RESOLUTION NO. 2025-13

**A RESOLUTION APPROVING SALMONBERRY TRAIL PREFERRED ALIGNMENT
IN ROCKAWAY BEACH**

Re: Task 4.1 Alternatives Analysis Technical Memo #2

Re: Salmonberry Trail, Rockaway Beach Segment Engagement Summary

SHEET NO.
C106
SHEET 06 OF 19

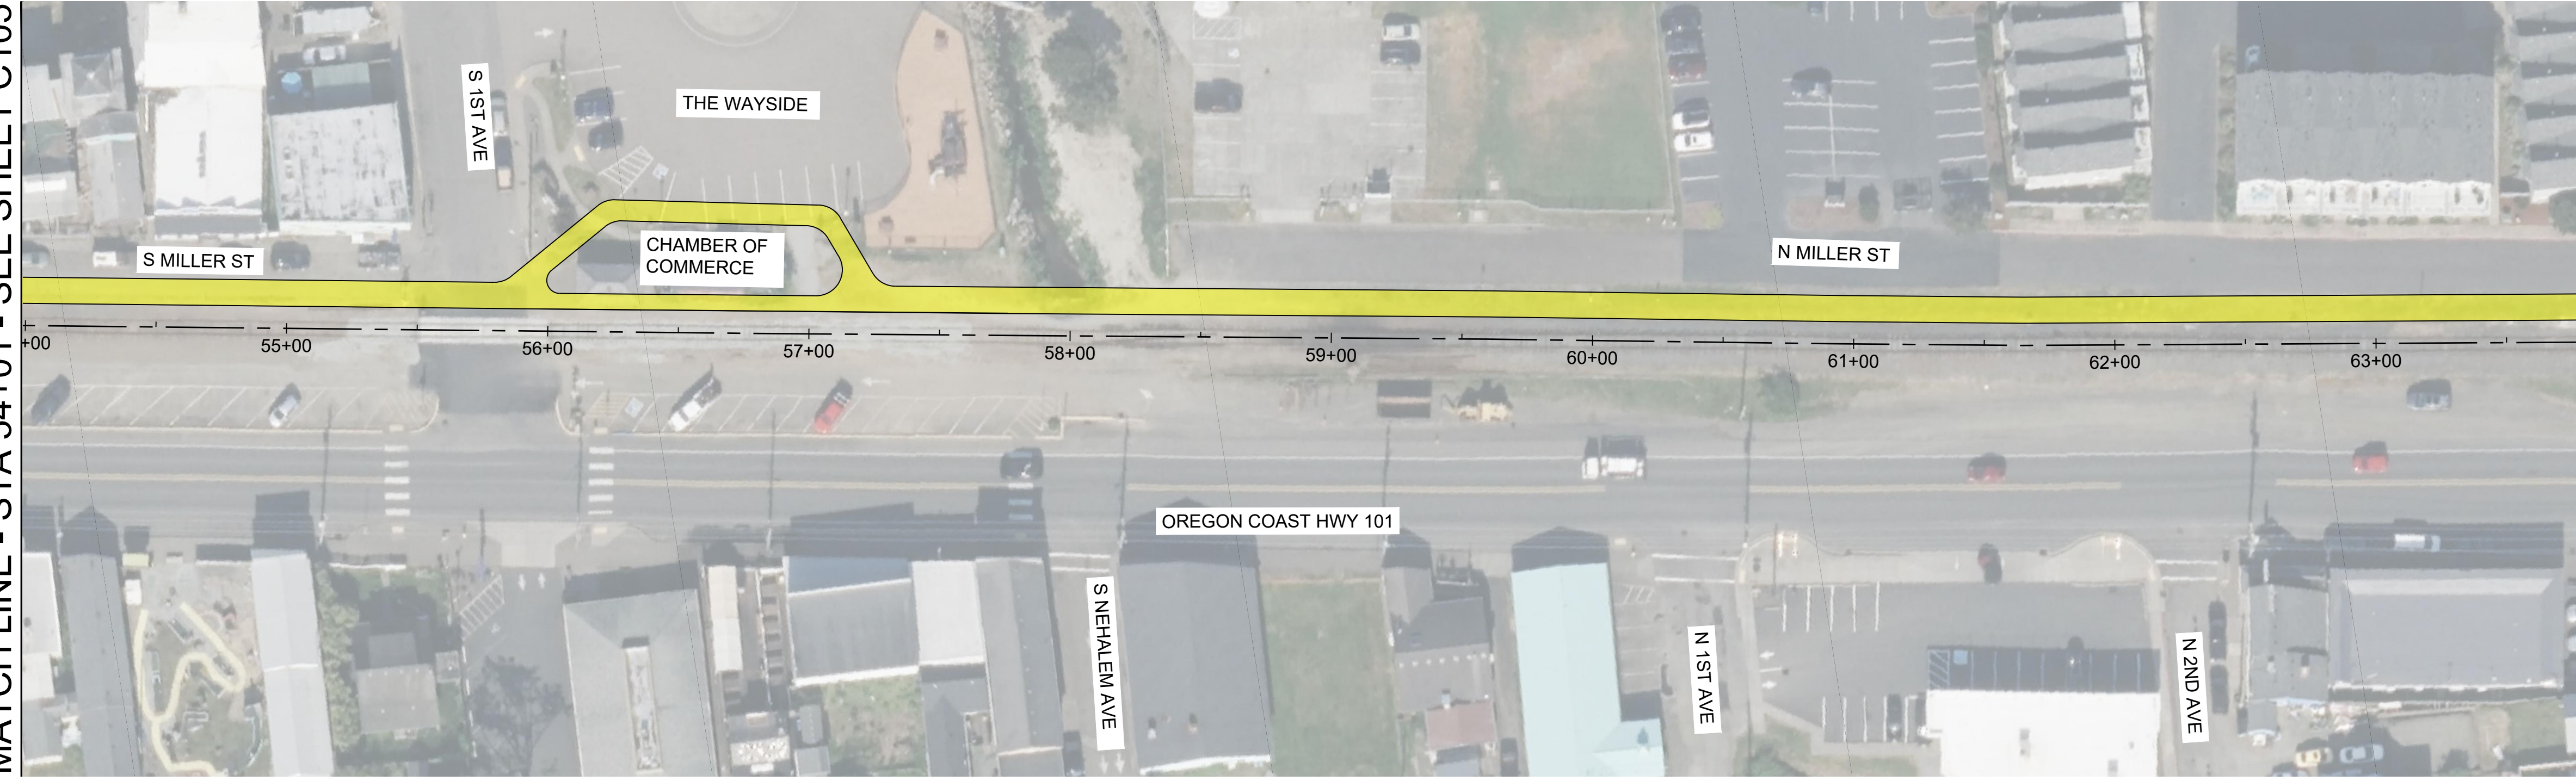
- Section 3.** The City Council generally approves of the preferred alignment detailed in Exhibit A; however, the City Council hereby directs staff to explore an alternative to the split path design around the caboose adjacent to South First Street.

D. CABOOSE STATION
STA. 55+50.00 to 57+80.00

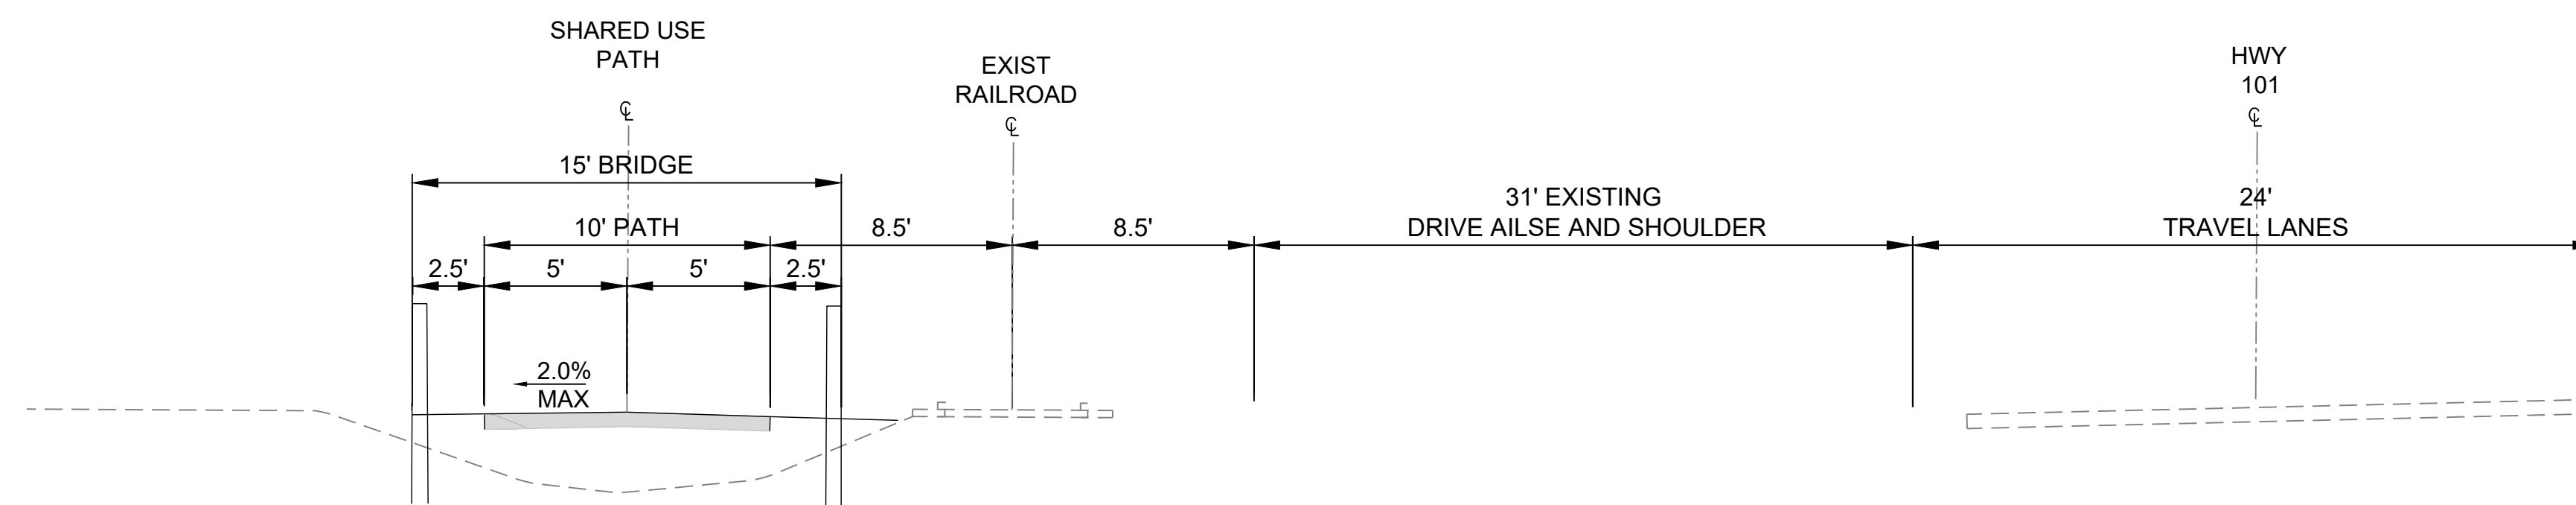
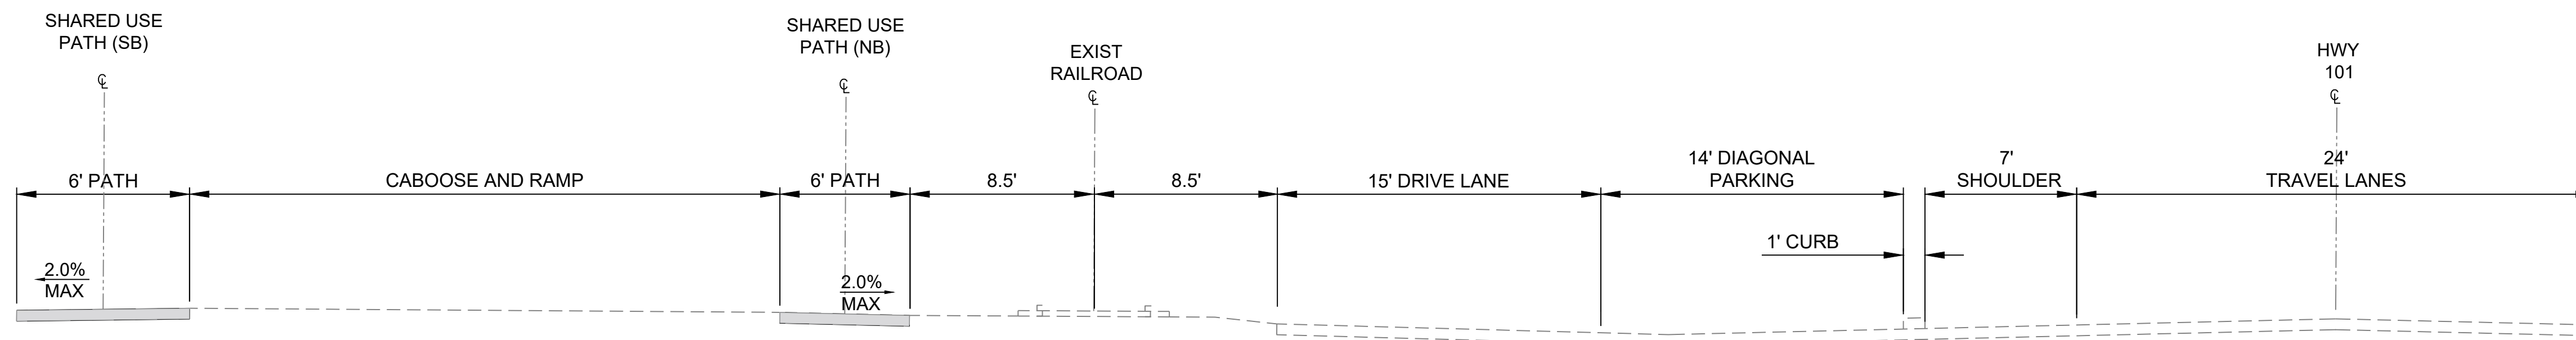
The split path is the preferred alignment in this section as it less costly to construct and could improve access to the scenic railroad and the Wayside. It also maintains existing parking and does not require moving the caboose. The downtown Rockaway Beach location of the trail could be a good area to add a trailhead with wayfinding signage and overall Salmonberry Trail information, something expressed from the public as being desirable, although an exact location has yet to be determined. At the northern end of the wayside is a creek which would require construction of a bridge. This would need to happen on the west side of the railroad which would connect the path to Miller St, which begins again at this location on the west side of the railroad and with informal parking on east side.
